TOWN OF LOS GATOS
HISTORIC PRESERVATION
COMMITTEE REPORT

SUBJECT: Consider a Request for Approval for a Revision to the Approved Exterior Materials (Siding) on a Pre-1941 Residence on Property Zoned R-1:8. **Located at 445 Los Gatos Boulevard.** APN 529-20-006. Request for Review Application PHSTY-26-002. Categorically Exempt Pursuant to CEQA Guidelines Section 15301: Existing Facilities. Property Owner/Applicant: Nam Nguyen. Project Planner: Sean Mullin.

Attn: Sean Mullins – Planner/Project Coordinator
Re: Application to Request for Approval of an Alternate Exterior Siding Material
APN: 529-20-006

Length = 7/8”
Length = 1/2”
Original
Hardie

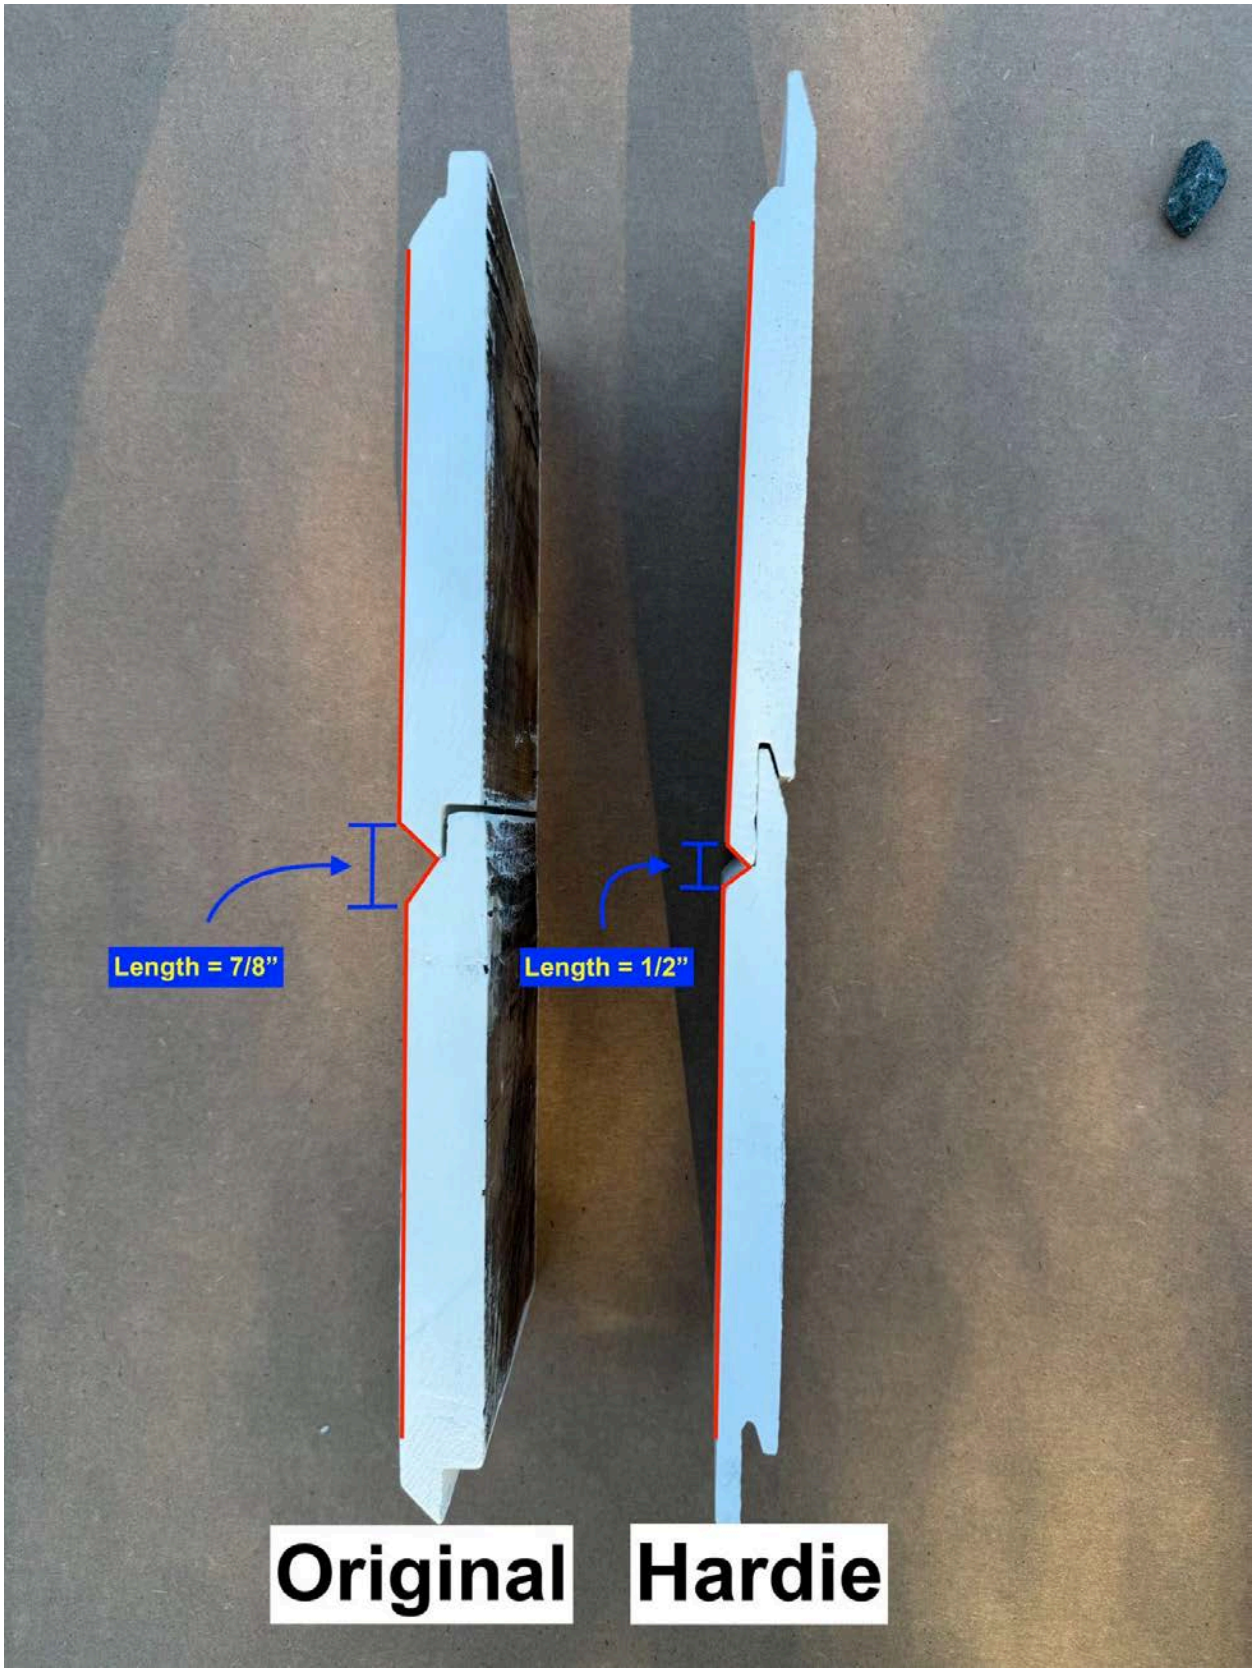
- Physical samples of the existing wood siding and the proposed James Hardie Artisan V-groove fiber-cement siding are provided side by side in closeup view for front-elevation comparison, demonstrating consistency with the home's historic architectural style and preservation of its visual character.

- Detailed photographic documentation of both materials showing the profile, illustrating the dimensional and visual characteristics of each. The material utilizes a V-groove profile that closely reflects the shape, size, dimension, texture and pattern of the existing wood siding, maintaining the established facade pattern.

- The proposed siding matches the original in visible width and profile, and the minimal difference in thickness has no discernible visual impact from the primary elevation, making the replacement visually indistinguishable to a lay person once installed.

SOUTH (SIDE) ELEVATION

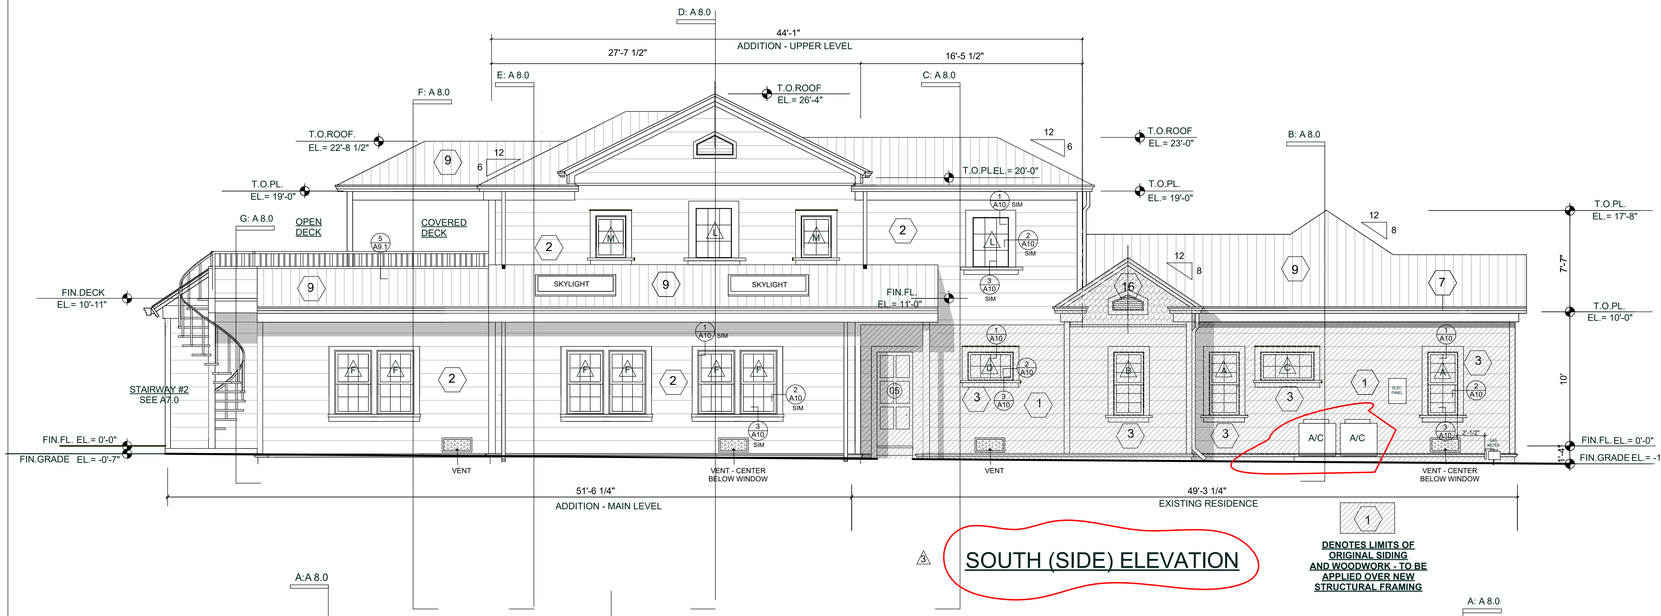
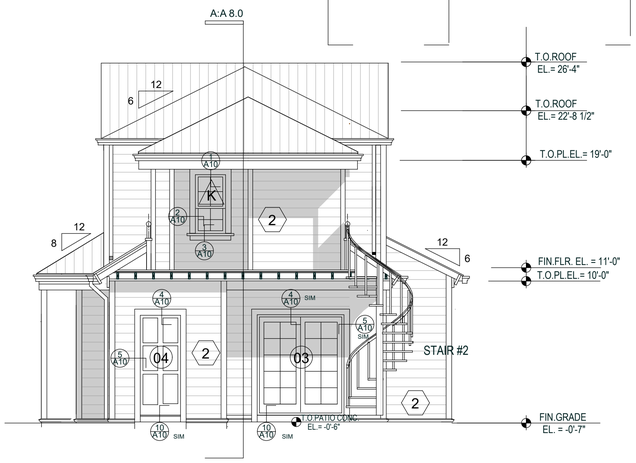
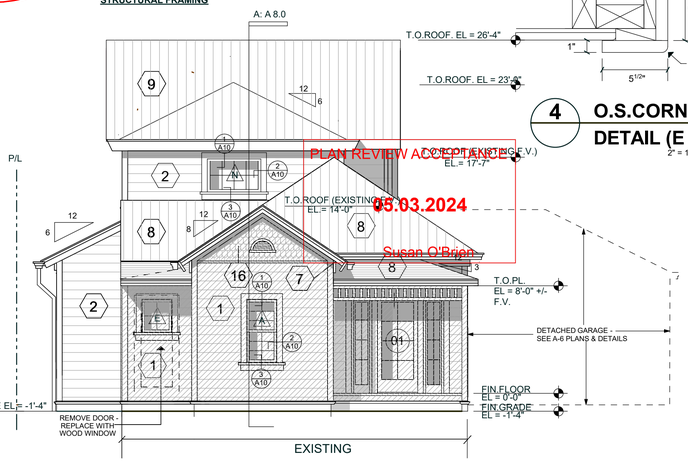
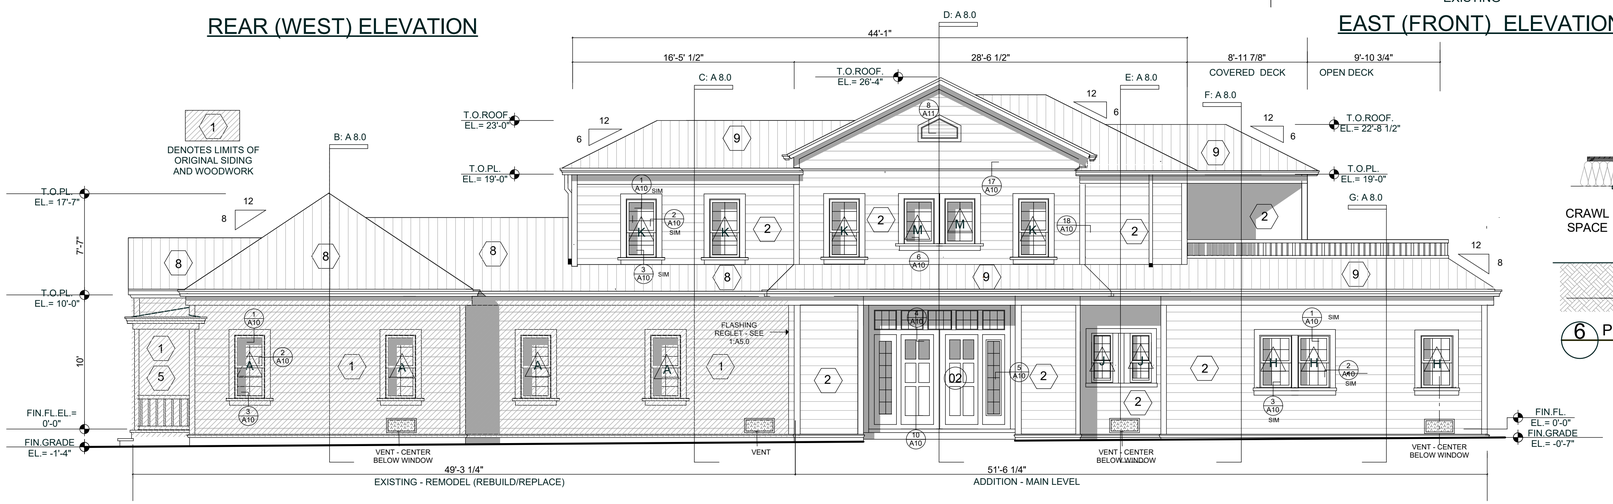
The applicant has returned to the Committee requesting approval for revisions to the approved exterior materials. Specifically, the applicant requests changing the approved wood siding to a cementitious siding material. In their Letter of Justification, the applicant indicates that the proposed Hardie Artisan V-Groove fiber cement siding would replicate the historic siding material while providing enhanced fire resistance and durability (Attachment 1). The applicant also notes that the materials consistency with relevant sections of the Residential Design Guidelines.
